Eagleton Residents Action Group

REF: Opposing the Eagleton Hardrock Quarry Development

Application No: SSD7332

Location: Lot 2 DP1108702, Barleigh Ranch Way, Eagleton

Figure 1: Koala Habitat Map for Port Stephens

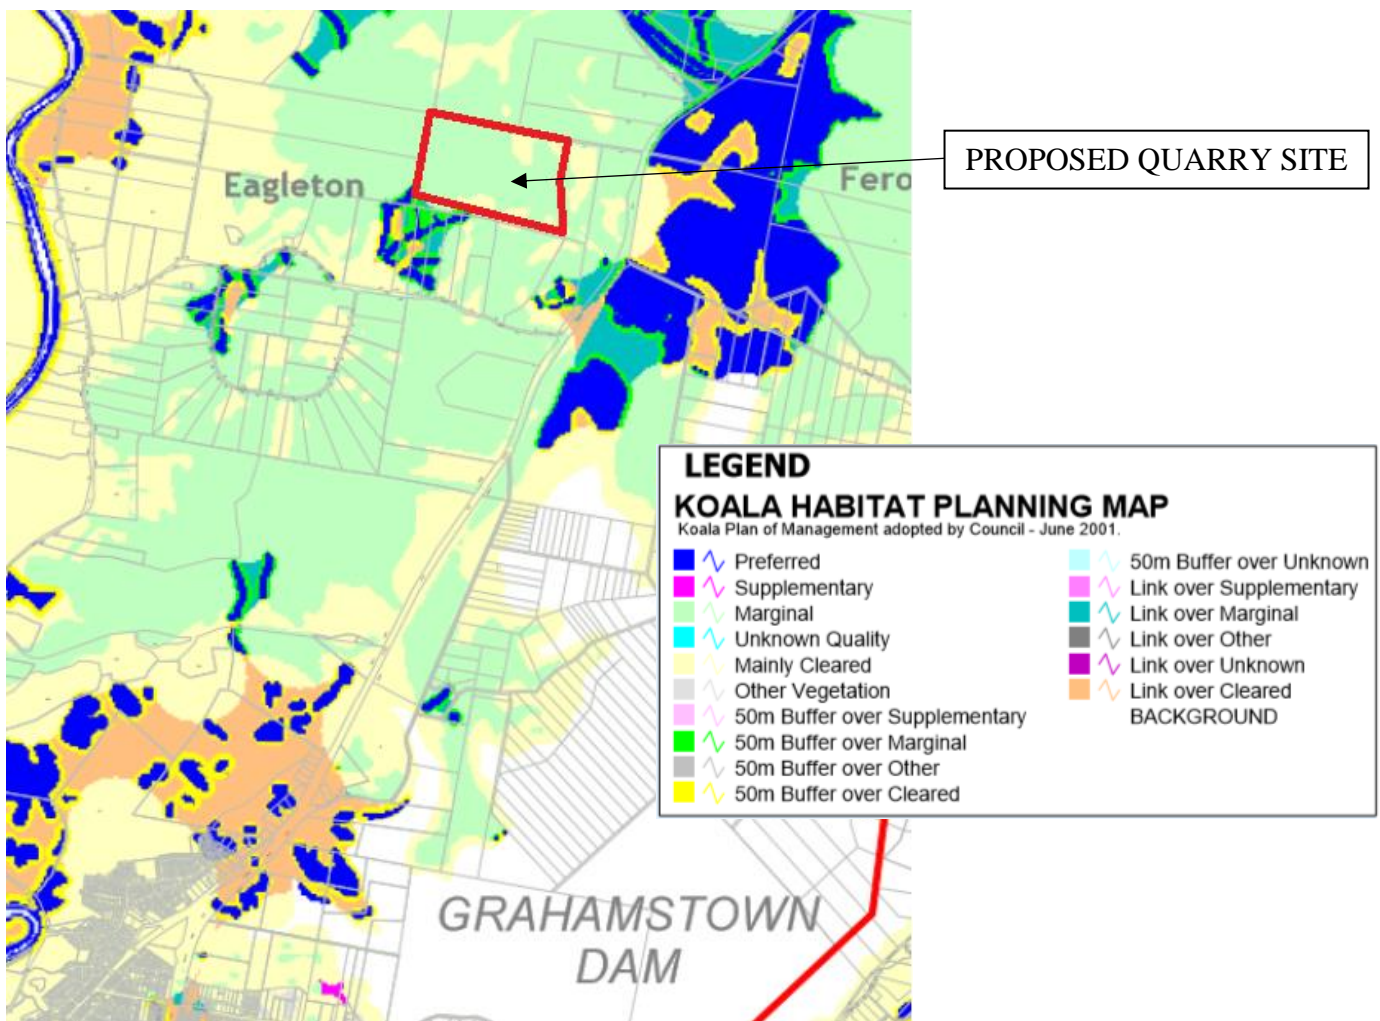
- 3.1. The State Government recognise that the koala's habitats, across the state, is under threat. This development will have a likely significantly impact on the local koala population, which is an unacceptable risk and threats to other vulnerable flora and fauna species are too great.
- 3.2. The subject site contains significant numbers of *eucalyptus punctate* trees. Since 2002, acknowledgment of this tree species as important, it is now commonly accepted by Port Stephens Council and the CKPOM steering committee and local experts, that koalas are known to use both *eucalyptus tereticormis* and *eucalyptus punctate* in this area and koalas have been located on this site and surrounds.

- 3.3. Overall the site is used by koalas as stated in surveys and we demand that an extensive survey be conducted over a minimum of twelve months, to fully assess the species on site.
